IEEE P802.15 Wireless Personal Area Networks

Project	Project IEEE P802.15 Working Group for Wireless Personal Area Networks (WPANs)									
Title	LB97 resolutions - Kivinen									
Date Submitted	11 July, 2014									
Source	Tero Kivinen Voice: +358 20 500 7800 INSIDE Secure Fax: +358 20 500 7801 Eerikinkatu 28 E-mail: kivinen@iki.fi FI-00180 Helsinki Finland									
Re:	LB97 resolutions									
Abstract	LB 97 resolutions to CIDs 1028, 1150, 1026, 1145, 1146, 1148, 1147, 1153, 1101, 1151, 1105, 1104, 1154, R41 and R42									
Purpose	LB97 resolutions									
Notice	This document has been prepared to assist the IEEE P802.15. It is offered as a basis for discussion and is not binding on the contributing individual(s) or organization(s). The material in this document is subject to change in form and content after further study. The contributor(s) reserve(s) the right to add, amend or withdraw material contained herein.									
Release	The contributor acknowledges and accepts that this contribution becomes the property of IEEE and may be made publicly available by P802.15.

New version of the Outbound state machine:

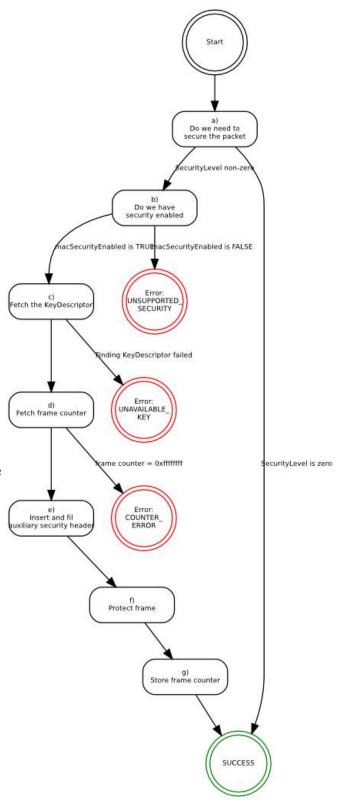
<u>CID 1028</u>

Robert	Verizon	313	9.2	16	Still need state machines for security flow	Provide state machine figures
Moskowitz

CID 1150

Secure length of the data expansion length if we are not protecting the frame. See CID 565.

Work In Progress, Outbound state machine done, see CID 1150 for it.
